**WEST AVE. ELEVATED STORAGE TANK
PAINTING AND REHABILITATION PROJECT
SAWS Job No. 18-0110
SAWS Solicitation No. B-20-008-SM**

**ADDENDUM 1
7/27/2020**

SAN ANTONIO WATER SYSTEM
WEST AVENUE ELEVATED STORAGE TANK
REHABILITATION PAINTING PROJECT
SITE PLAN

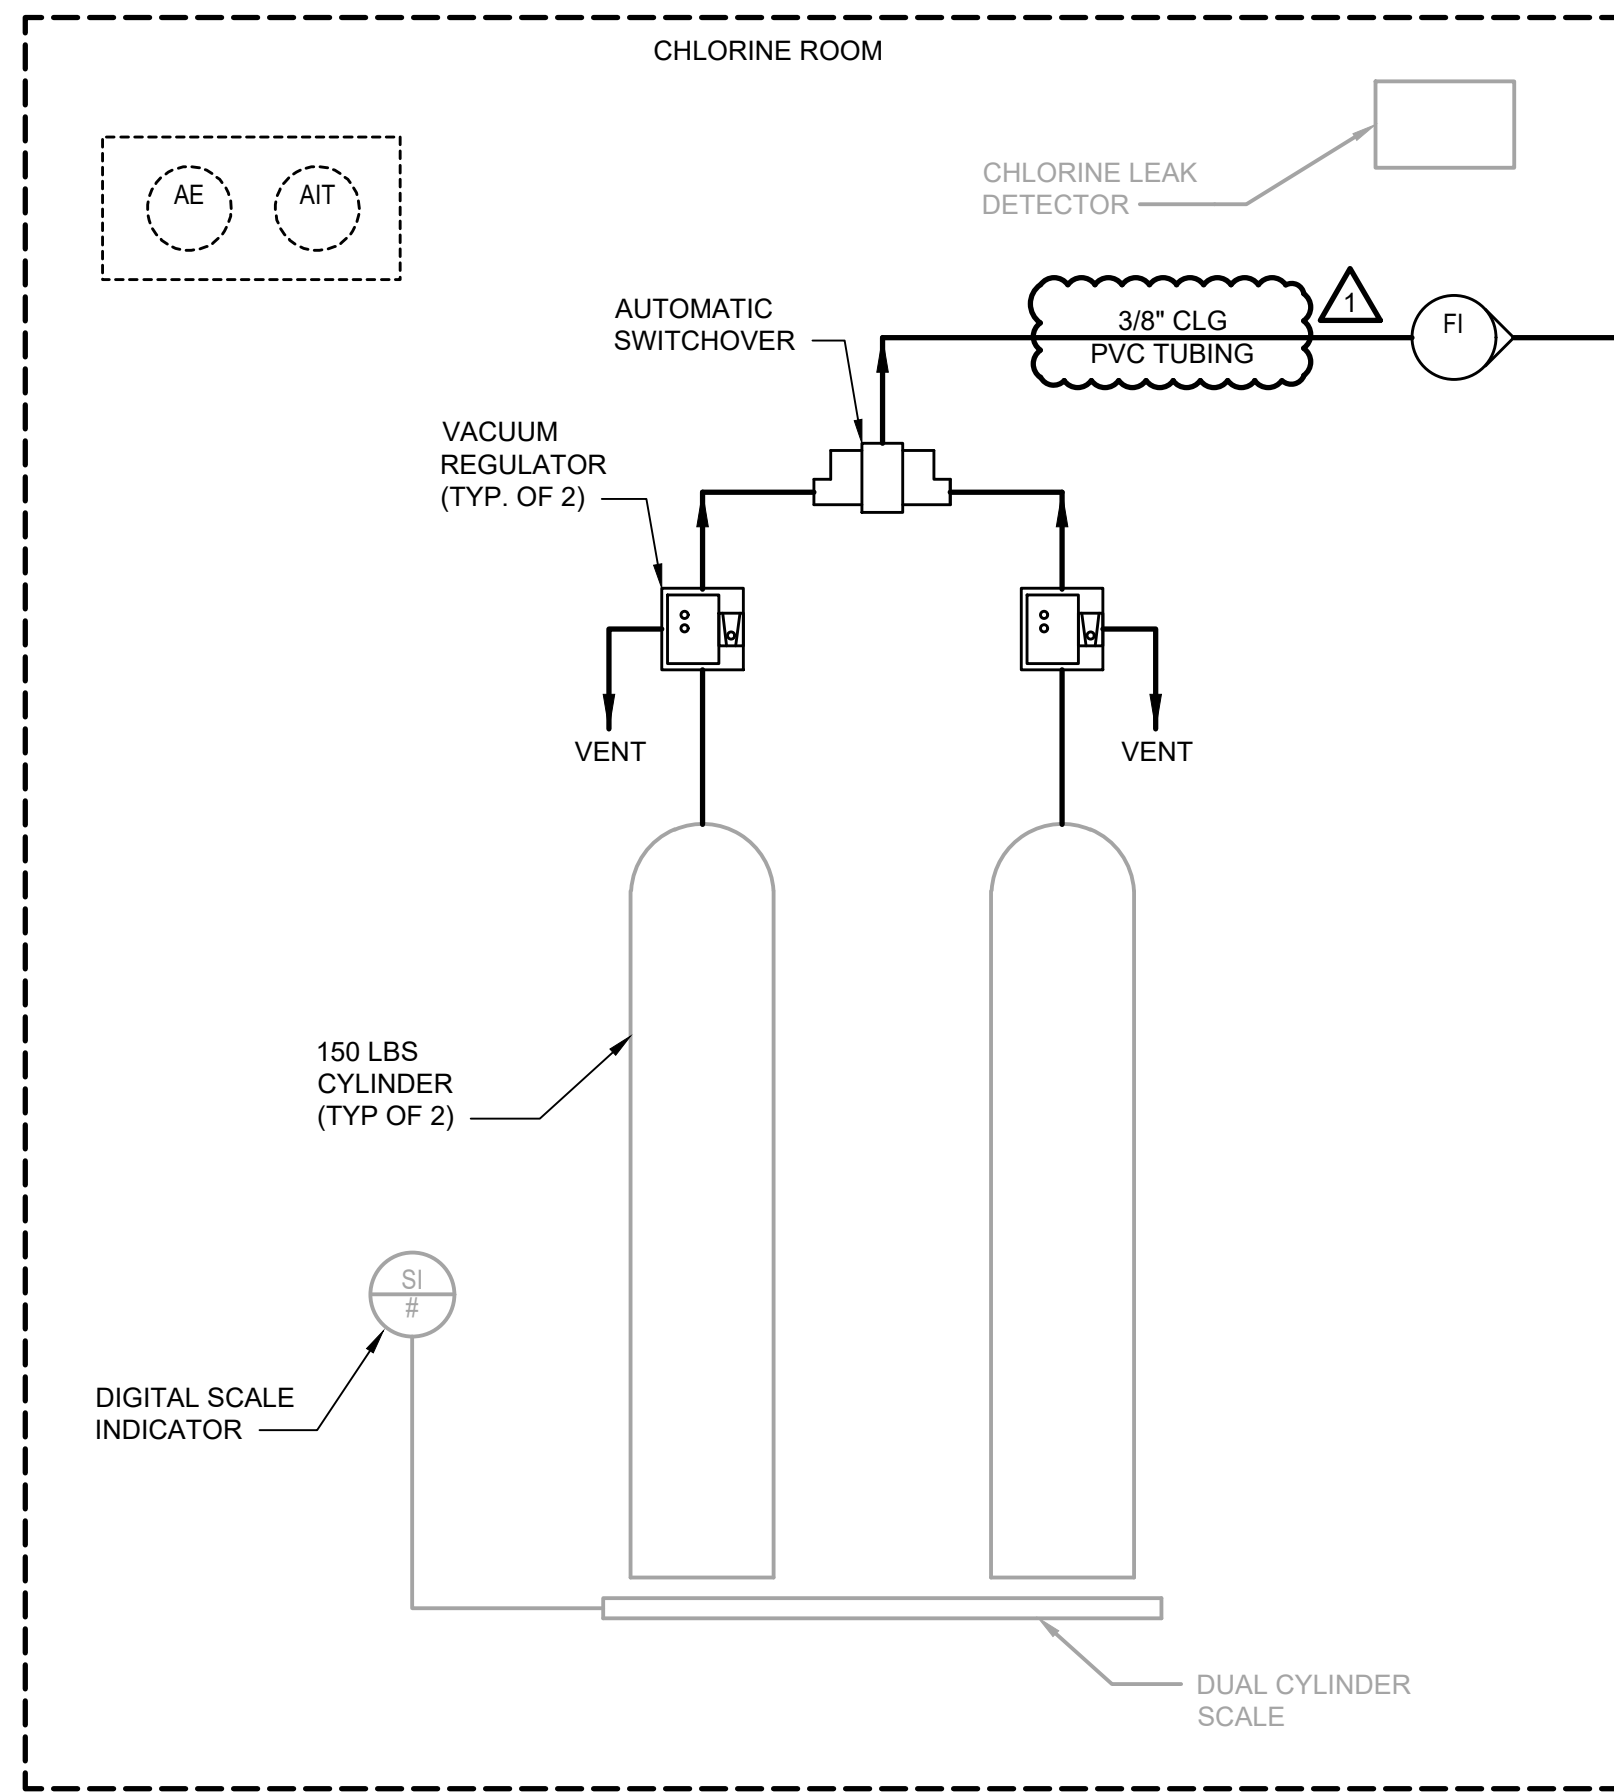
- 1. DELETE drawings CS-102, CS-103 and CS-104 and REPLACE with the sheets attached in this Addendum.

MARK	DATE	DESCRIPTION	BY
1	07/17/20	PER ADDENDUM #1	MK
